**Docket Items #6 A-C**  
**ACPS Modular Classroom Addition(s)**  
**Charles Barrett - Development Site Plan #2010-0005**  
**Patrick Henry – Development Site Plan #2010-0010**  
**James K. Polk – Development Site Plan #2010-0009**

**Staff Recommendation: APPROVAL WITH CONDITIONS**

**DSP #2010-0010  
PATRICK HENRY ELEMENTARY  
4643 TANEY AVENUE**

DSP #2010-0009  
JAMES K. POLK ELEMENTARY  
5000 POLK AVENUE

**Figure #3 – Patrick Henry Proposed Option #2 Addition**

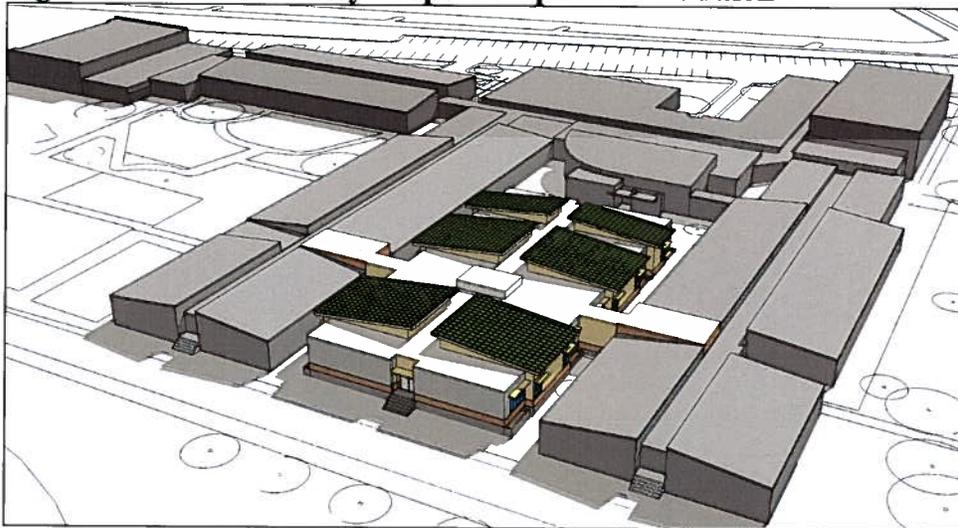
Option#2 is the applicant’s preferred option to meet the needs of the anticipated Fall 2011 enrollment with the least amount of impact to the existing playground areas. If Option#2 is selected, only one 11,186 square-foot single-story addition would be proposed on the northwest side of the existing school in a courtyard bracketed by two wings of the school. This addition would connect to the existing school through two new corridors, as depicted in *Attachment #1*, and would include 10 primary classrooms.

**Figure #4 – James Polk Proposed Addition**

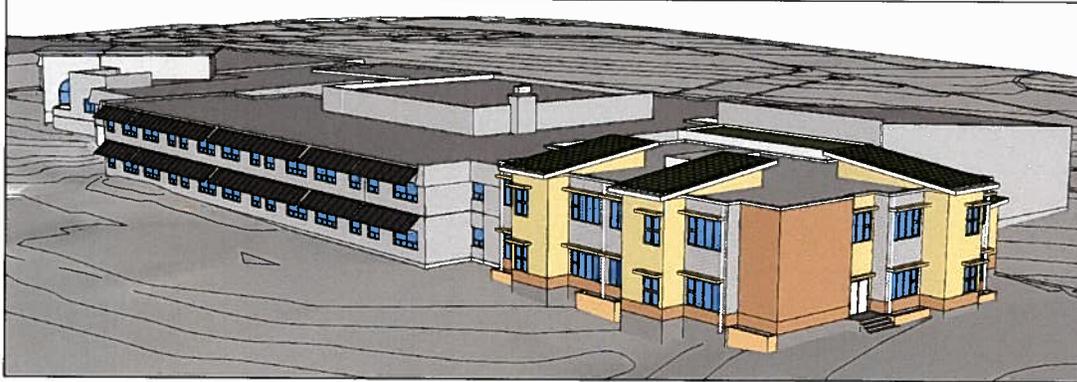
A 11,768 square-foot two-story addition is proposed on the southeast side of the existing school, on a grassy area next to the existing parking lot, in between the new 6,240 square foot gymnasium addition (DSP#2009-0009) and single-family homes. The proposed modular addition will connect to the school by adding on to the end of an existing corridor and through a new vestibule connecting to the gymnasium. The addition includes eight (8)

primary classrooms, two new restrooms and a new stage platform that will connect to the existing gymnasium.
